Re: Water Treatment Plant – Construction Contingency Expense No. 4

Proposal No. 017 (RFP 012): Filter Slab Modifications:

Request For Proposal No. 012

Re: Filter Slab Modifications

DRAWING
S504

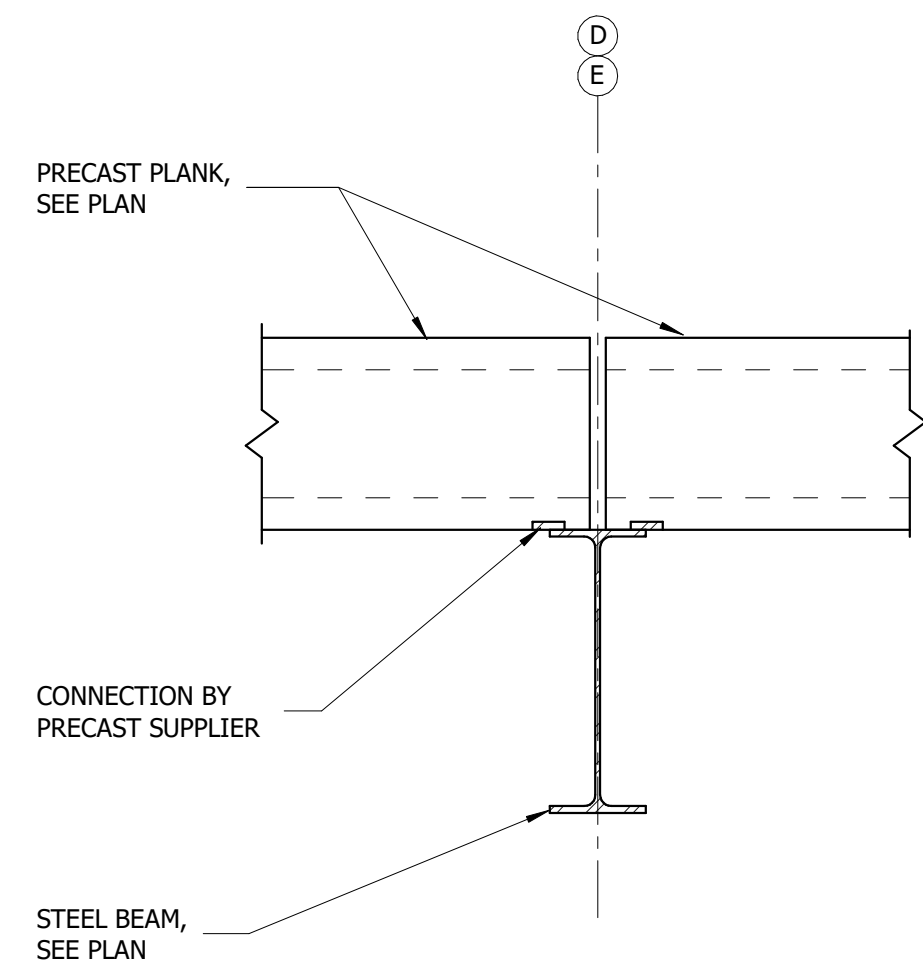
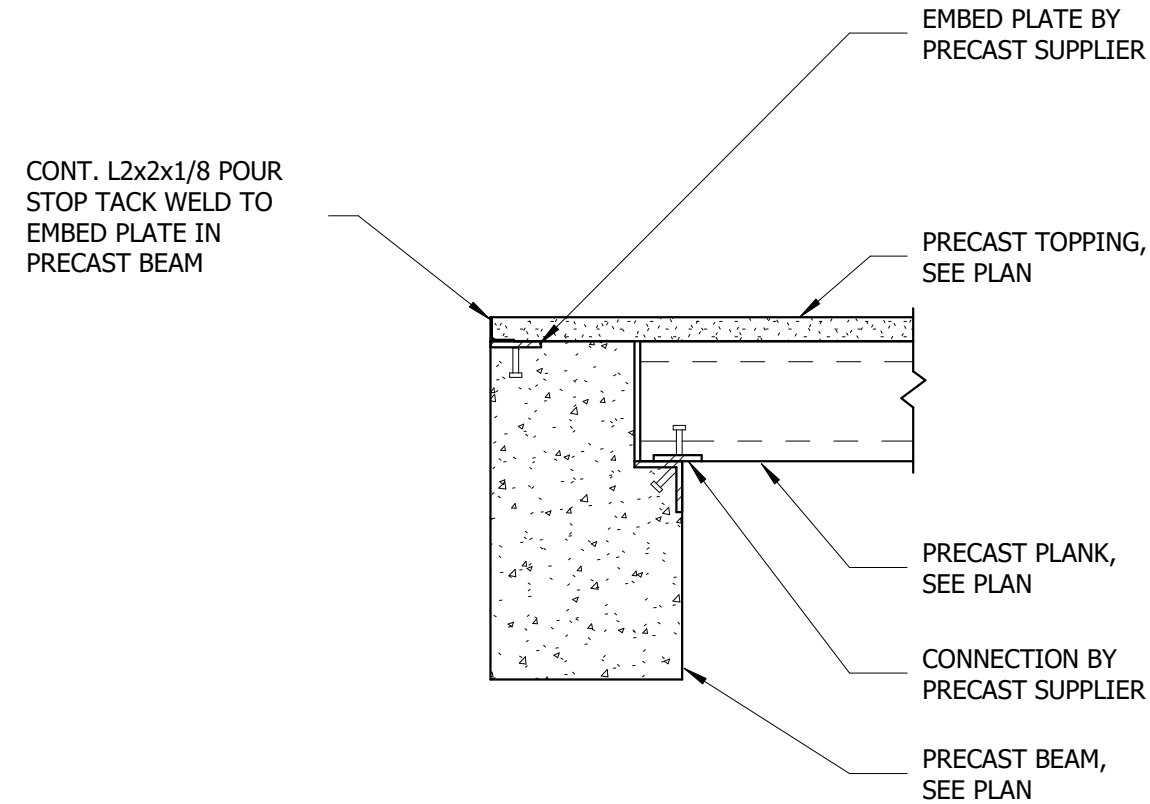
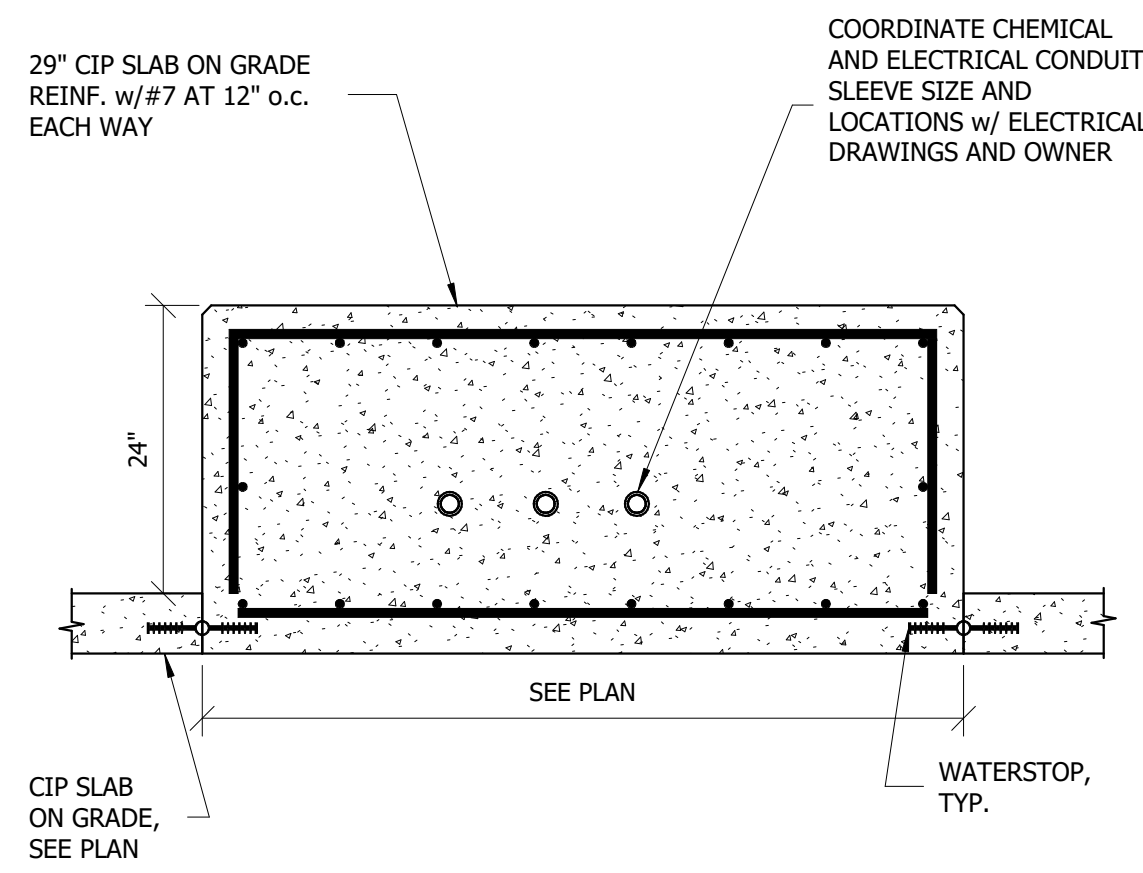
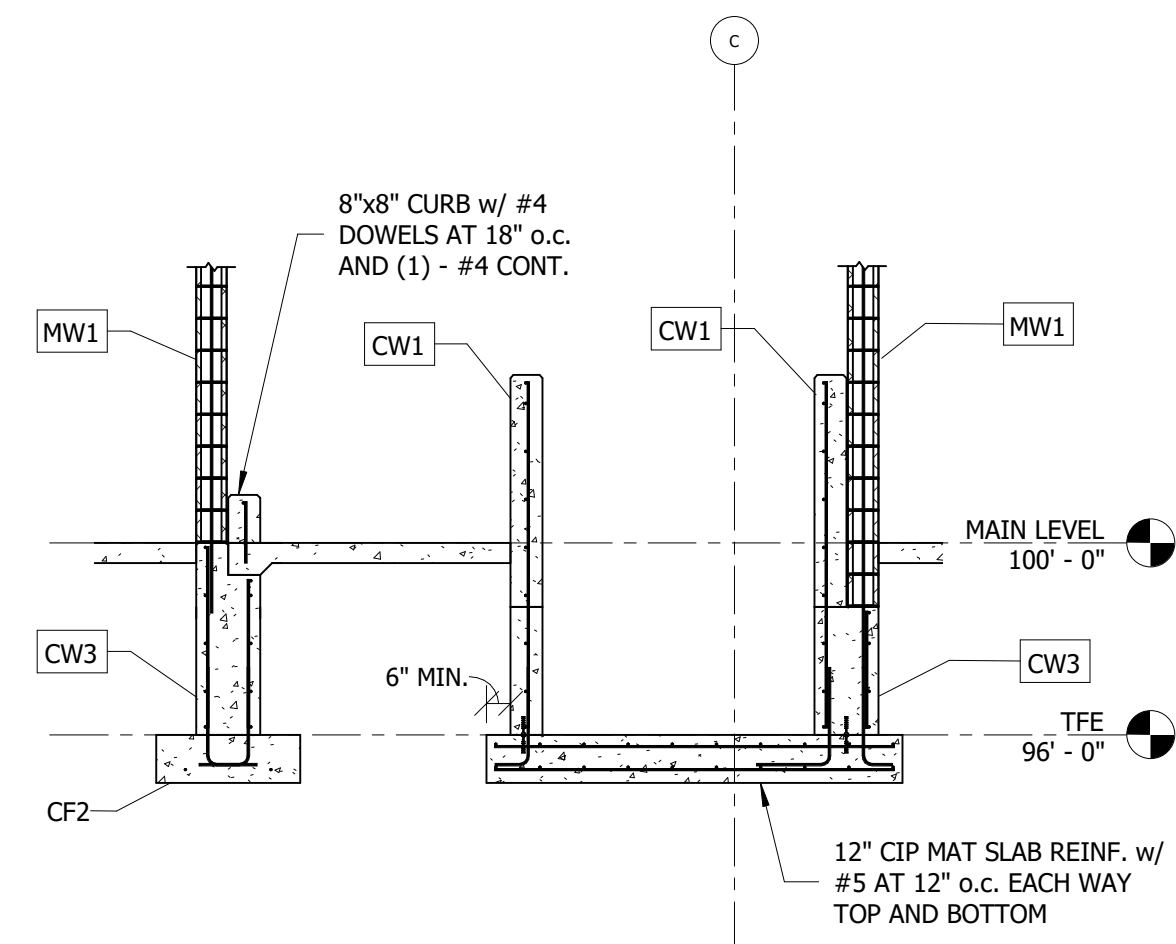
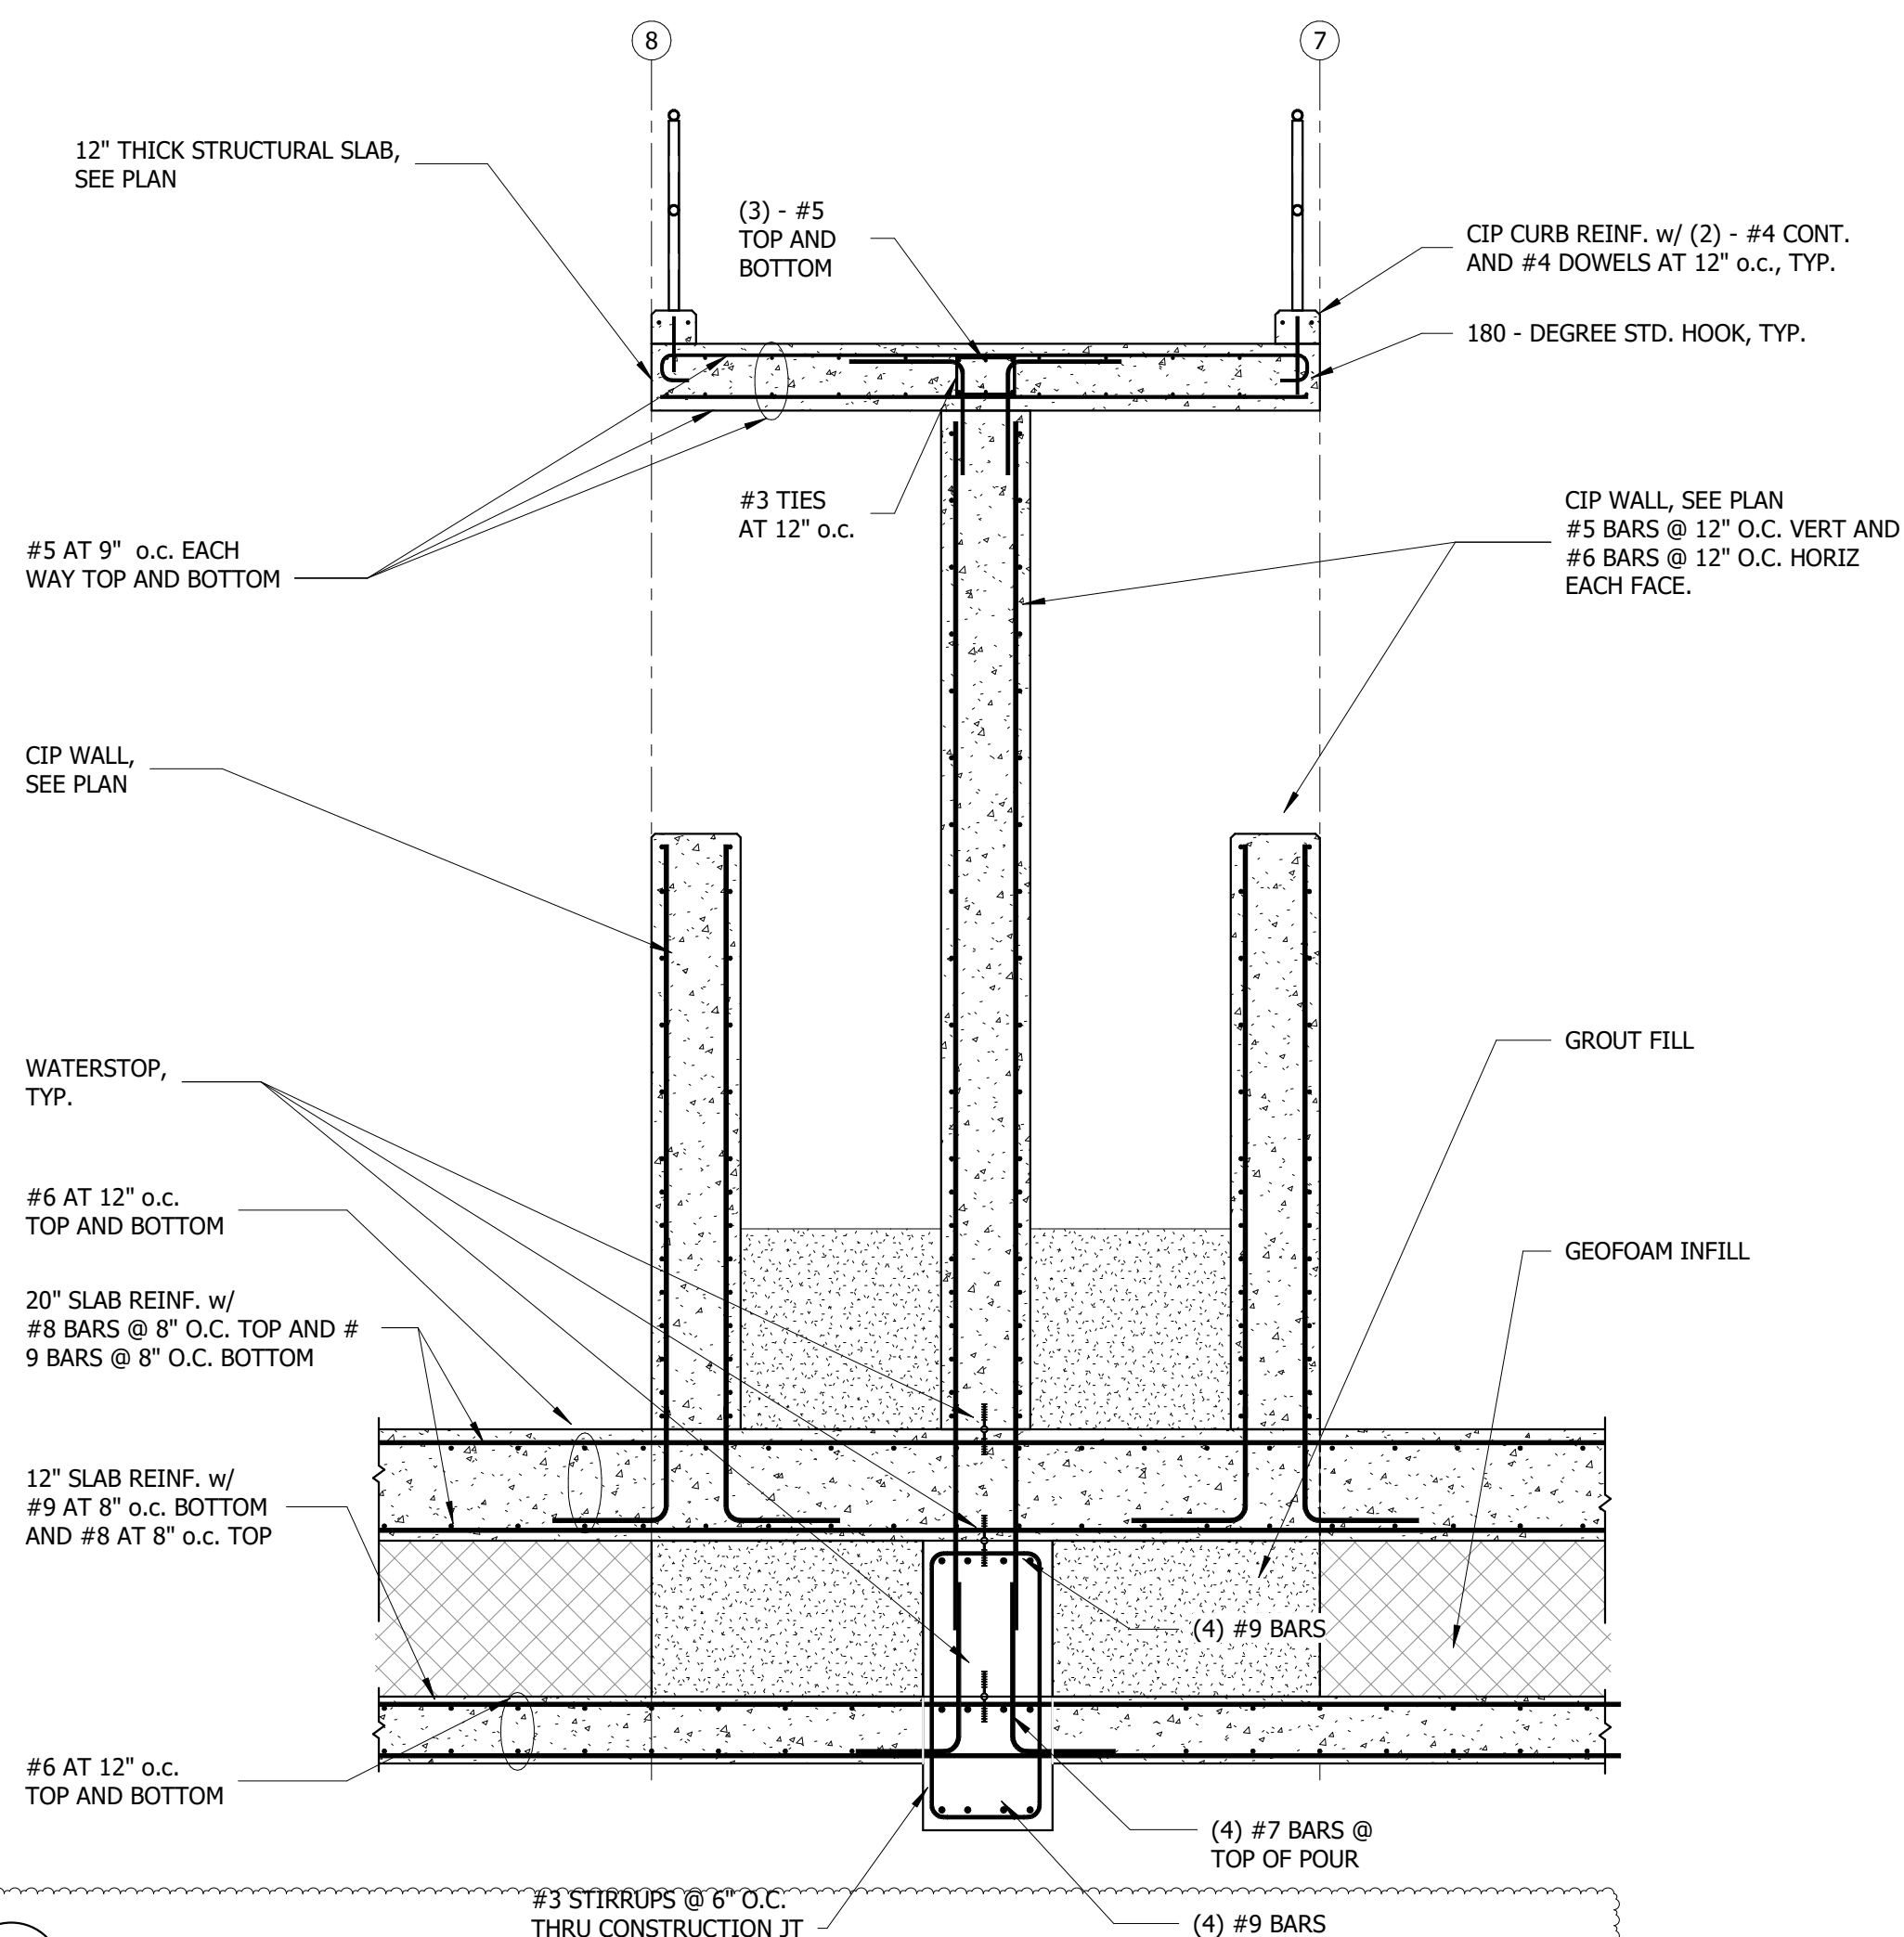
AE2S requests pricing from Magney for changes to the filter slab and CIP supports beams in the clearwell and backwash reclaim tank. Changes include but are not limited to extending the filter slab at elevation 113', increasing the slab thickness to 20" and increasing the CIP beams in the clearwell and backwash tank from 24" to 52". We also request pricing for raising the height of the gullet wall and filter trough to 121'-11". See attached drawings for any additional changes required. Once approved, Contractor will need to resubmit submittal 135 – Concrete reinforcement WTP structural slab, based on provided drawings. See sheets S203, S301, S302, S303, S305, S504, S505 and S601 attached.

Ryan,
Magney Construction, Inc. is pleased to present the following quotation to furnish the necessary labor, material, and equipment to complete the requested changes in RFP 012 - Filter Slab Modifications. To extend and thicken the slab at 113' with required rebar modifications, increase the Clearwell and Backwash beam heights to 52". Along with raising the gullet walls to 121'11". The costs associated with change are summarized below.
